NIAGARA FALLS AIR RESERVE STATION

MILITARY ENTRANCE PROCESSING STATION

PN 59873

INVITATION FOR BID DECEMBER 2004

Sheet reference number:
A–201

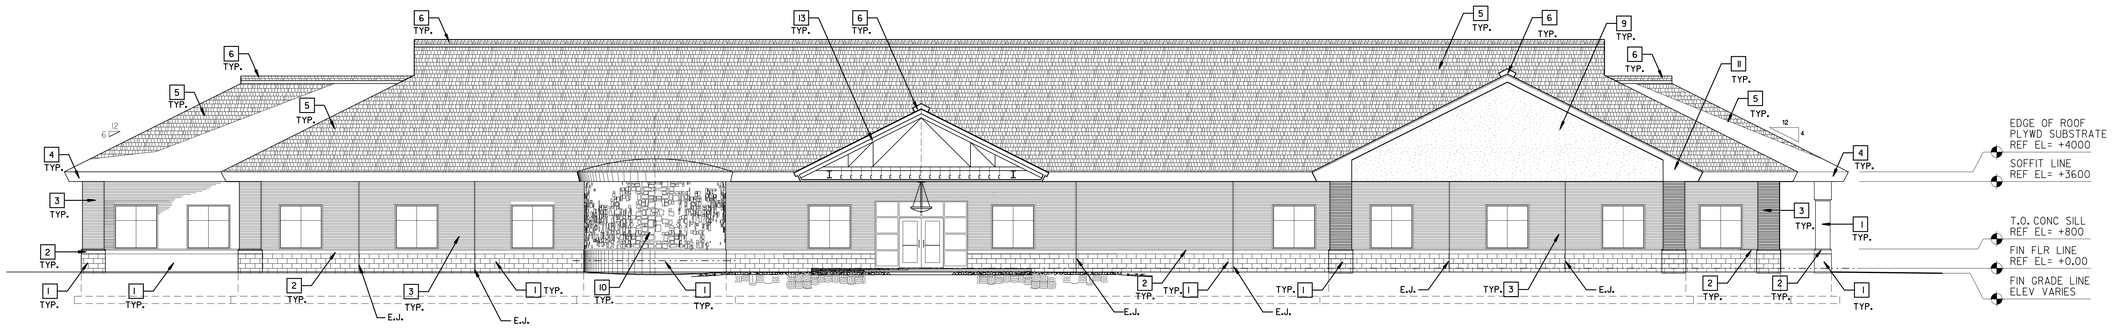
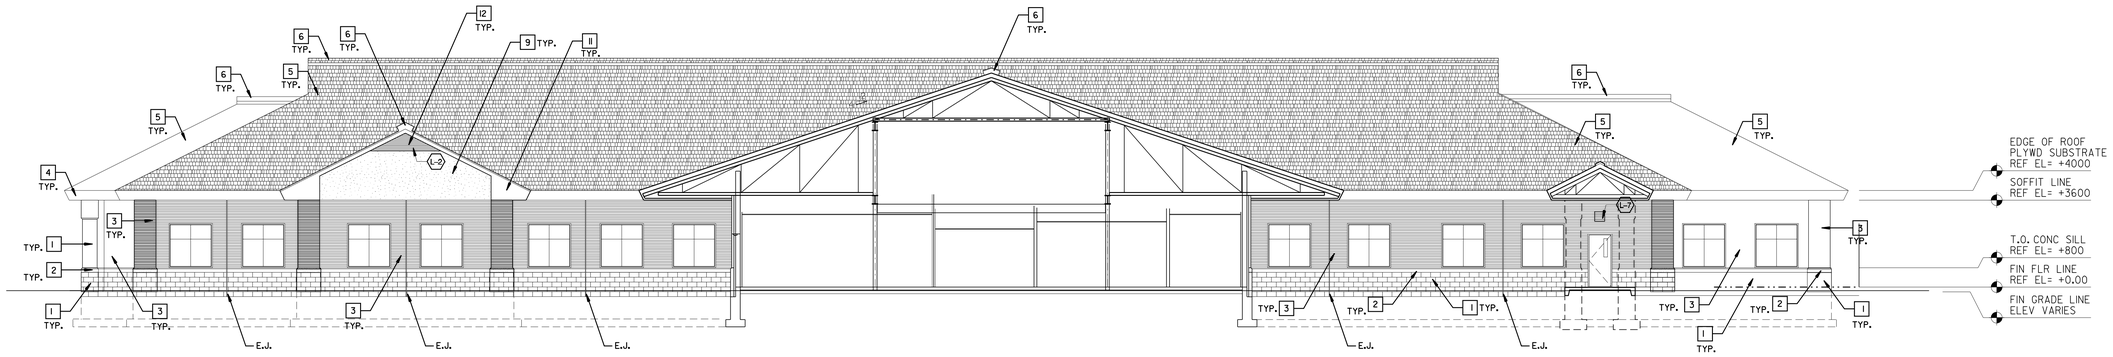
Symbol	Description	Date	Appr.
1	AMENDMENT #1-ADDED COLD ROOF CALCULATIONS	12/02/04	
	90% SUBMISSION	10/04/04	
	60% SUBMISSION	08/04/04	
	35% SUBMISSION	05/04/04

"COLD ROOF" VENTILATION CALCULATIONS

1. VALUES ARE FOR A 4:12 ROOF SLOPE
2. ROOF THERMAL RESISTANCE =R 30
3. AIR WAY HEIGHT = 50mm
4. AIR WAY LENGTH = 15,392mm
5. TOTAL VENTED SOFFIT LENGTH = 205,200mm
6. TOTAL VENTED RIDGE LENGTH = 107,600mm
7. SOFFIT NET FREE AREA = 8,516sq.mm/1In ft / OF SOFFIT

8516 sq mm X 205.2M OF SOFFIT = 1,747,483 sq mm TOTAL FREE AREA AT SOFFIT
1,747,483 sq mm SOFFIT FREE AREA / 107.6M OF RIDGE LENGTH=16,240.5 sq mm OF RIDGE FREE AREA PER FT.OF RIDGE.
16,240.5 sq mm OF RIDGE FREE AREA / 2 = 8,120 sq.mm FREE AREA / SIDE OF RIDGE

1) ITEM #7 (SOFFIT NET FREE AREA) HAS BEEN CALCULATED BASED ON 'CRELL' CRITERIA FOR "ATTIC & CATHEDRAL CEILING VENTILATION"

2) SHEATHING GAP AT RIDGE MUST BE CONTINUOUS AND A MINIMUM OF 125mm WIDE.

Sheet reference number:
A–401

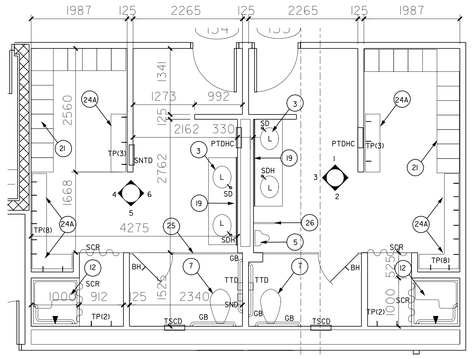
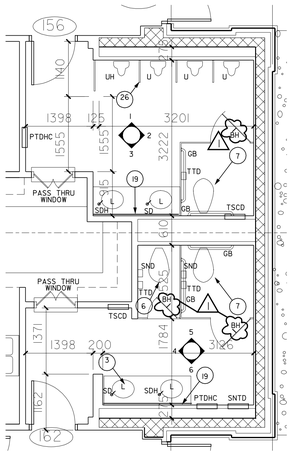
Symbol	Description	Date	Appr.
1	AMENDMENT #1- ADDED NOTE FOR TOILET PARTITION DOORS	12/02/04	
	90% SUBMISSION	10/04/04	
	60% SUBMISSION	06/09/04	
	15% SUBMISSION	03/19/04

1. SEE DWG. A-105 FOR WALL & FLOOR TILE PATTERNS.
2. SEE DWG. A-600 FOR INTERIOR FINISH SCHEDULE.
3. SEE DWG. A-701, DETAIL 19 FOR LAVATORY DETAIL.
4. ALL TOILET PARTITIONS DOORS @ ROOM 156 AND ROOM 162 ARE TO BE INSTALLED IN A 90 DEGREE OPEN POSITION.

Sheet reference number:
A–700

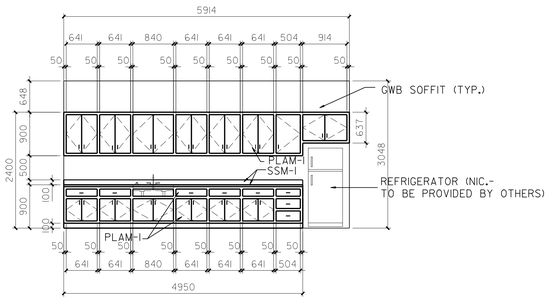
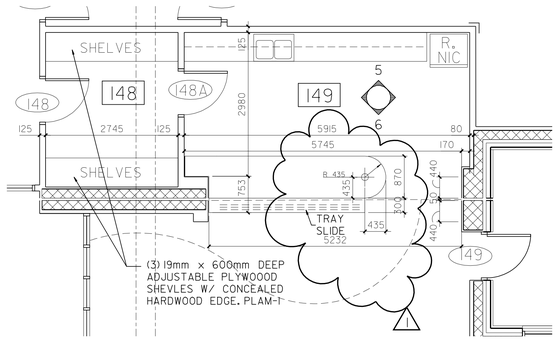
Symbol	Description	Date	Appr.
1	AMENDMENT #1- REVISED COUNTERTOP FOR FOOD PREP AREA 149, DELETE NOTE FOR STEAM TABLE	12/02/04	
	90% SUBMISSION	10/14/04	
	50% SUBMISSION	06/30/04	
	15% SUBMISSION	03/19/04

20 FOOD SERVICE COUNTER ROOM 149 DETAIL
SCALE: 1:10

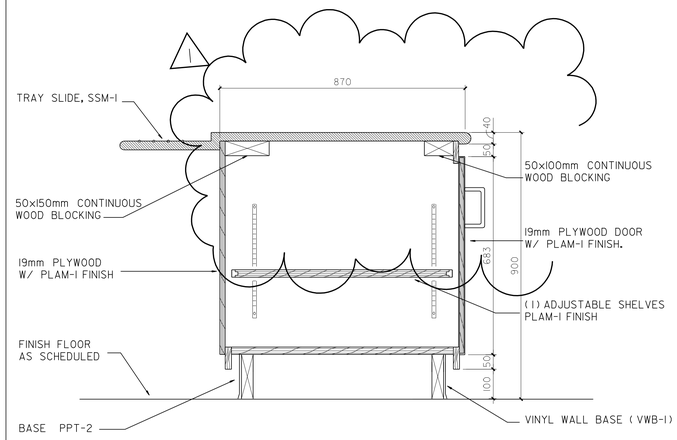
Symbol	Description	Date	Appr.
1	AMENDMENT #1- REMOVED STEAM TRAY FROM SERVICE COUNTER	12/20/04	
	90% SUBMISSION	10/14/04	
	60% SUBMISSION	08/30/04	
	15% SUBMISSION	03/19/04

Sheet reference number:
E–04

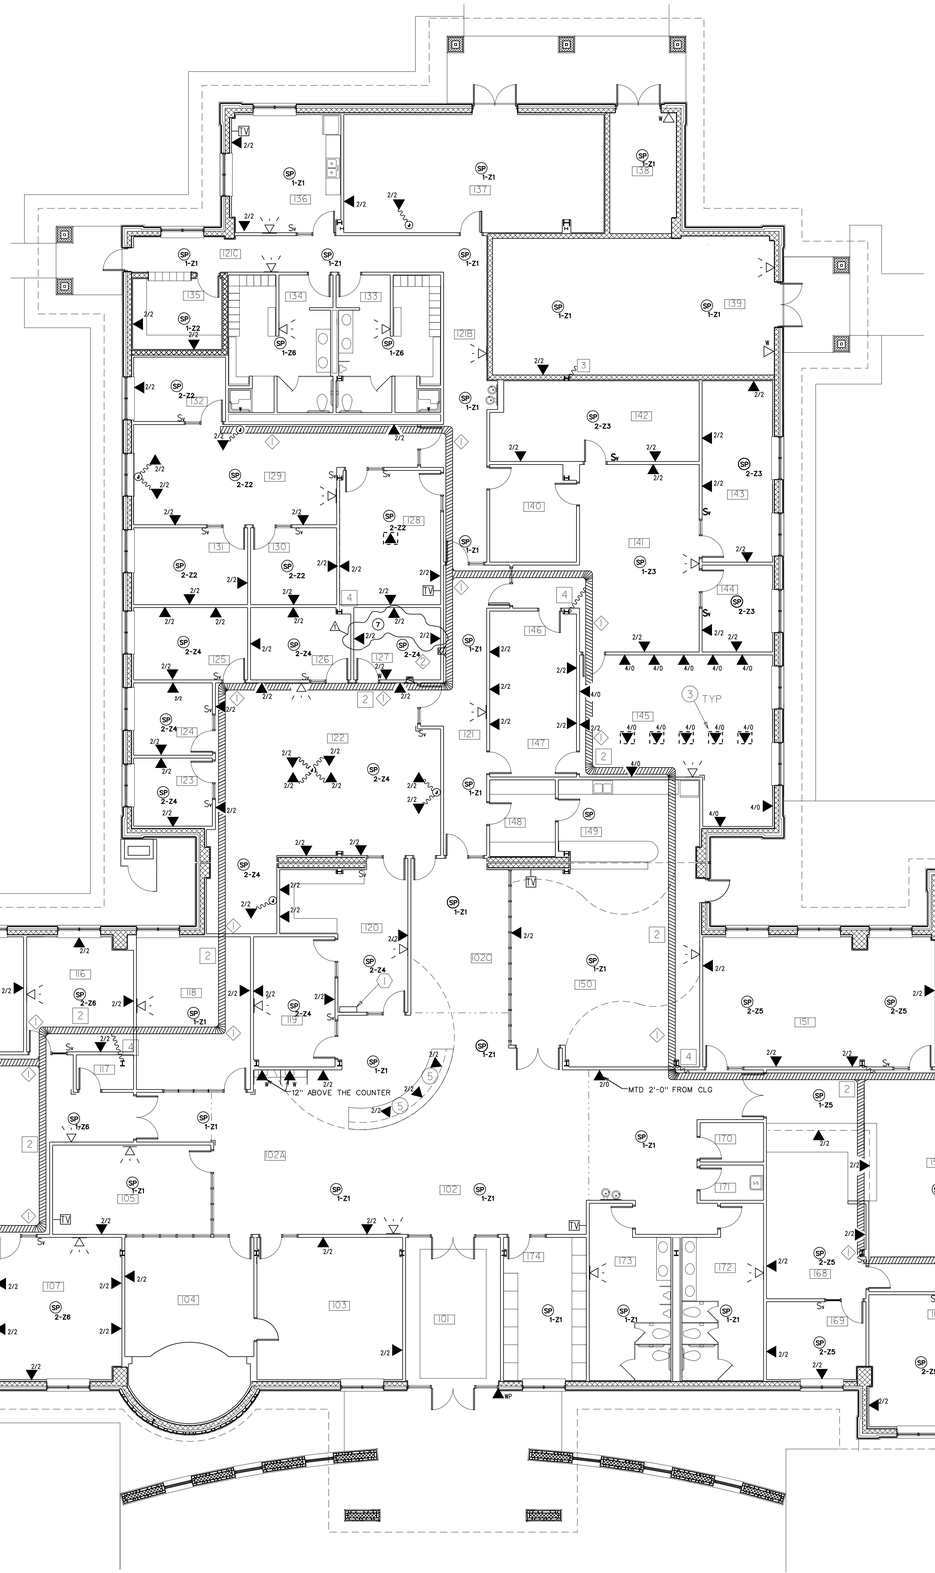
Rev.	Date	Description	Appr.
A		ADDED 3 VOICE / DATA OUTLETS AND RELOCATED 1 VOICE / DATA OUTLET

1 E1 E5 SINGLE LINE DIAGRAM
N.T.S.

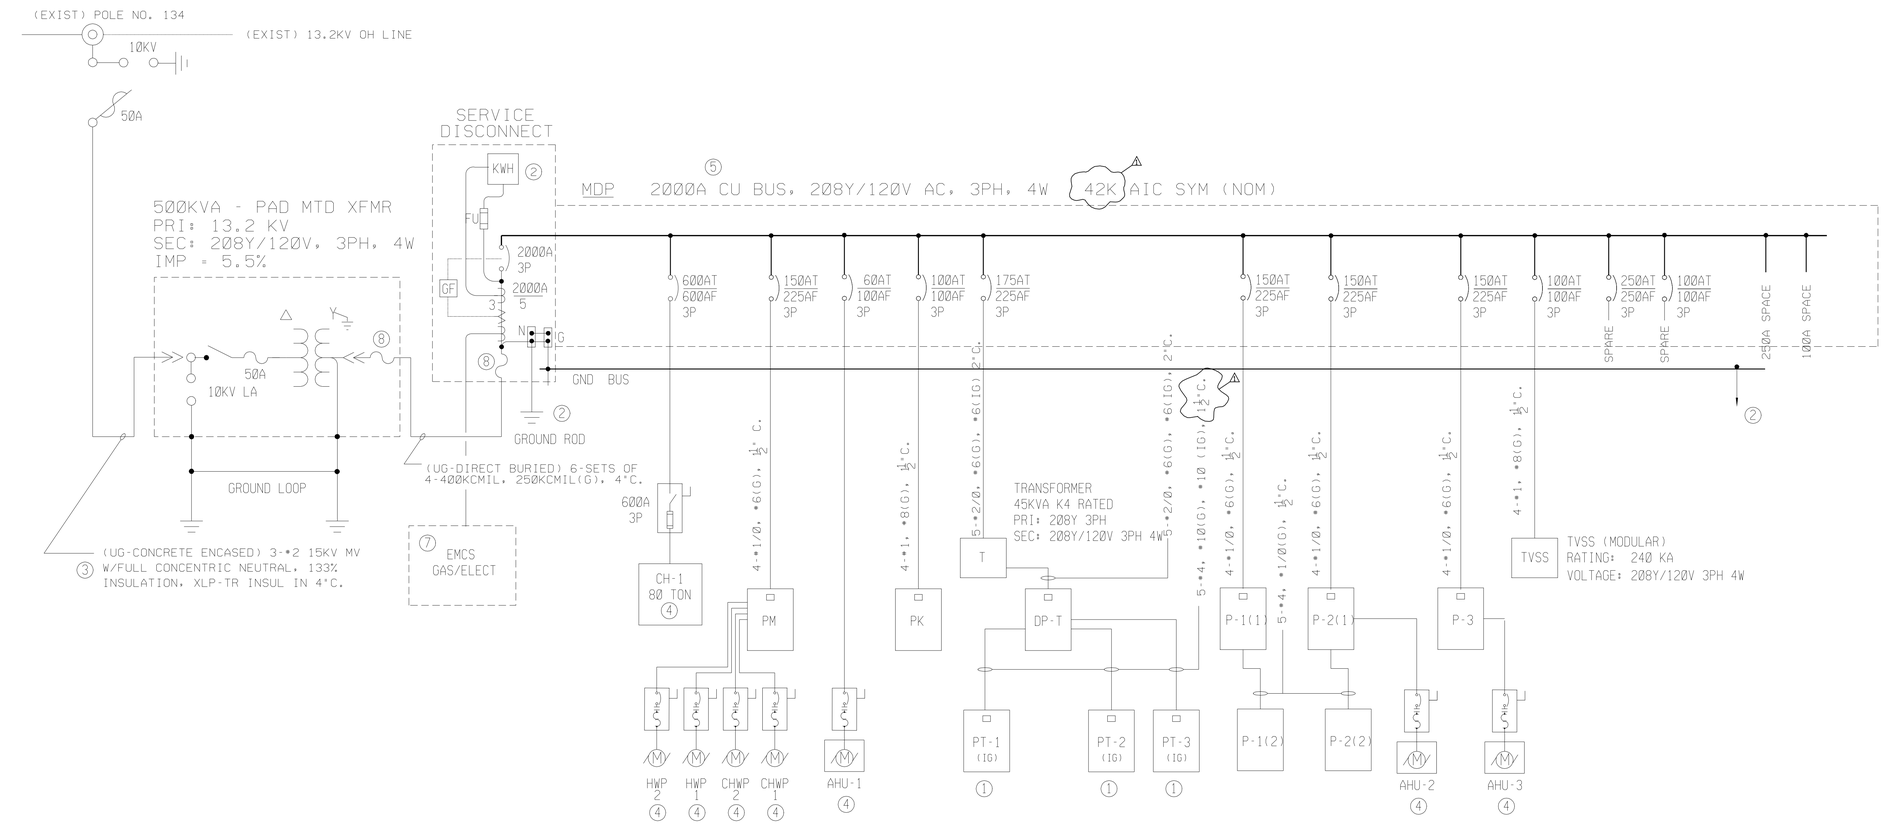
Symbol	Description	Date	Appr.
A	REVISED MDP INTERRUPTING CAPACITY AND CONDUIT SIZE	12-02-04

1 E4 E9 GROUNDING SYSTEM SCHEMATIC DIAGRAM
N.T.S.

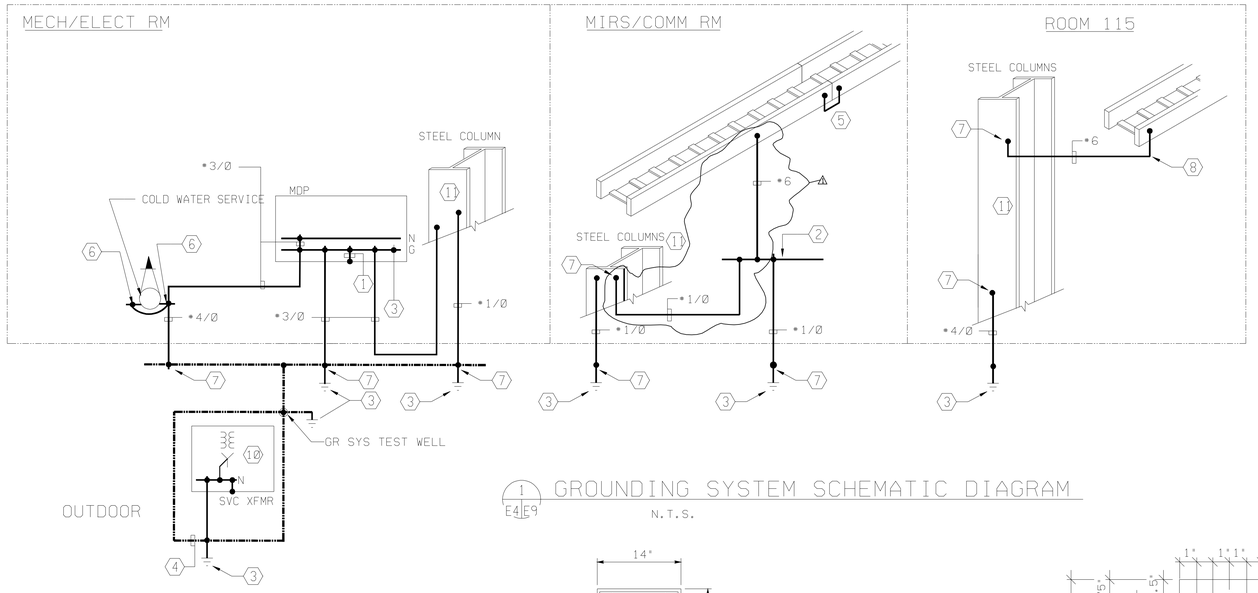
Symbol	Description	Date	Appr.
1	REVISED GROUNDING SYSTEM SCHEMATIC DIAGRAM	12-2-04

Sheet reference number:
S–102

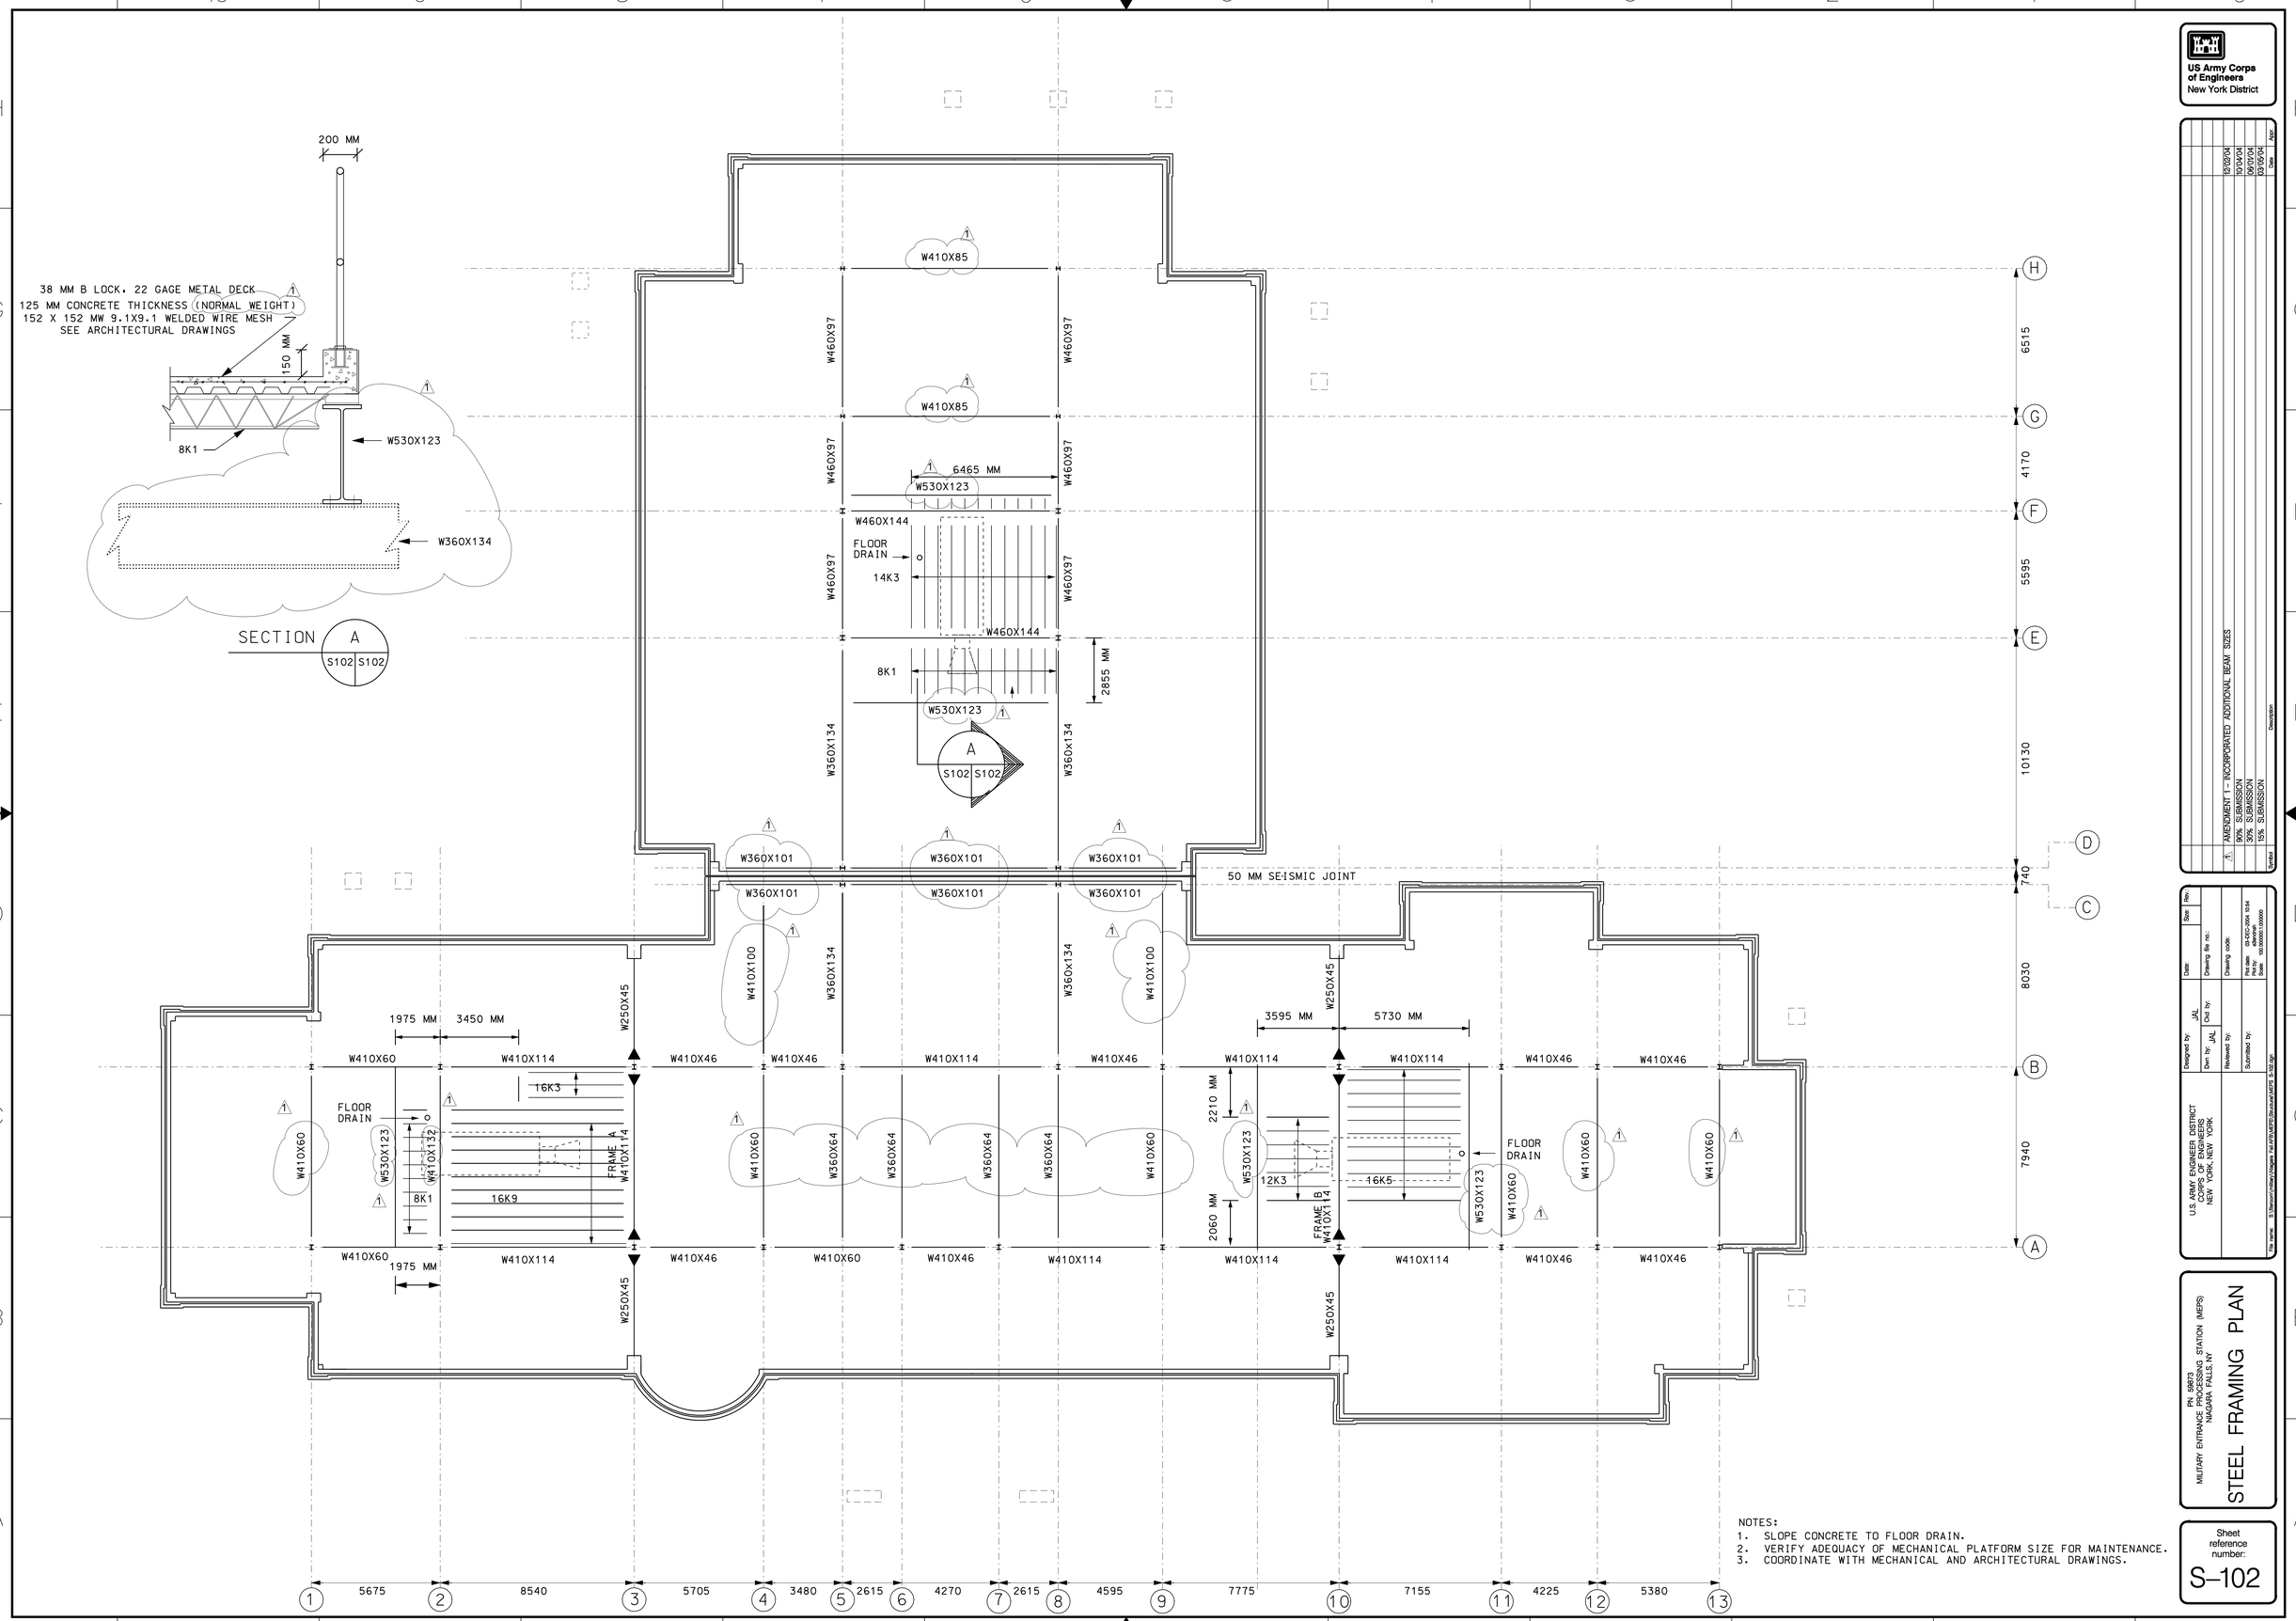
Rev.	Description	Date	Appr.
1	AMENDMENT 1 - INCORPORATED ADDITIONAL BEAM SIZES	12/20/04	
	90% SUBMISSION	10/14/04	
	60% SUBMISSION	06/07/04	
	15% SUBMISSION	03/30/04
